ADDRESSEES	: ABC Customer Care and Parts Source Owners and users of vehicles mentioned under "Application"
VEHICLE TYPE	: T2100, C2045, CX..., TX..., TD925US
CONFIGURATION GROUP	: 7.06 Steering – front-axle steering
BULLETIN TYPE	: Safety Recall NHTSA 17V-064/TC 2017-064
DATE	: February 15 th , 2017
SUBJECT	: Replacement of front axle steering system bevel gear
TERMS & CONDITIONS	: Refer to the warranty section further in this Bulletin.

The safety recall, subject of this Bulletin, is applicable to the following coach models equipped with the first generation Pailton bevel gear in the front steering system:

First generation Pailton bevel gear	Second generation Pailton bevel gear (additional dust cover at input and output shafts)	ZF bevel gear

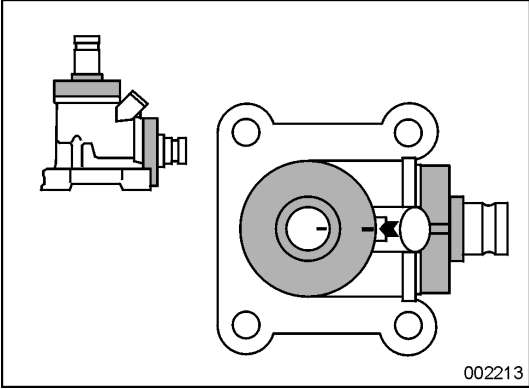
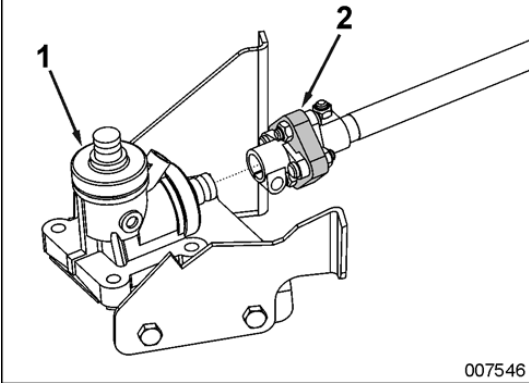
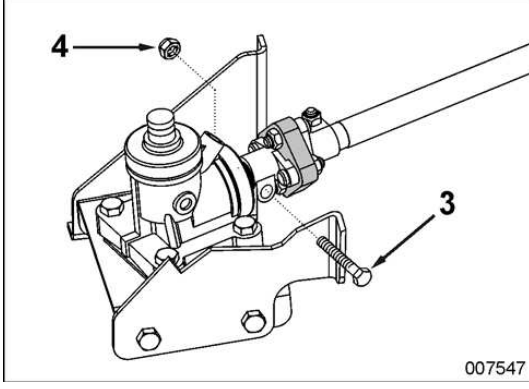
- Owners and operators of coaches equipped with a Pailton bevel gear should first identify their bevel gear. If the vehicle is equipped with a first generation Pailton bevel gear, it must be replaced by a corresponding ZF bevel gear. **The Pailton bevel gears of the second generation are not affected!**

Pailton and ZF bevel gears are interchangeable, but note that the ZF bevel gear has a mid-position which should be taken into account during the installation of the bevel gear.

2. To remove the bevel gear

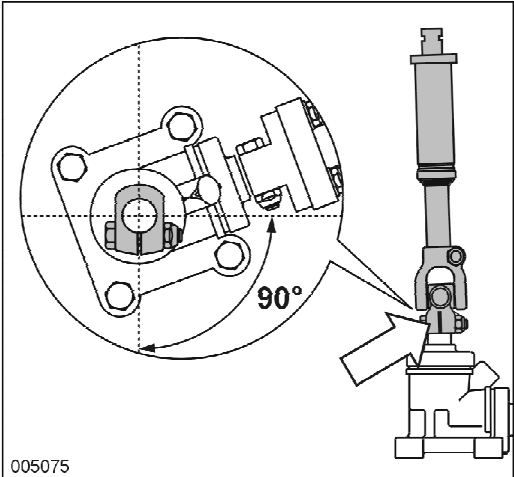
Step	Action
1	Make sure that the front wheels are in the straight-ahead position.
2	Remove the bolt of the steering column universal joint at the bevel gear.
3	Remove the bolt of the intermediate shaft elastic coupling at the bevel gear.
4	Remove the four bolts securing the bevel gear to the chassis and take away the bevel gear.
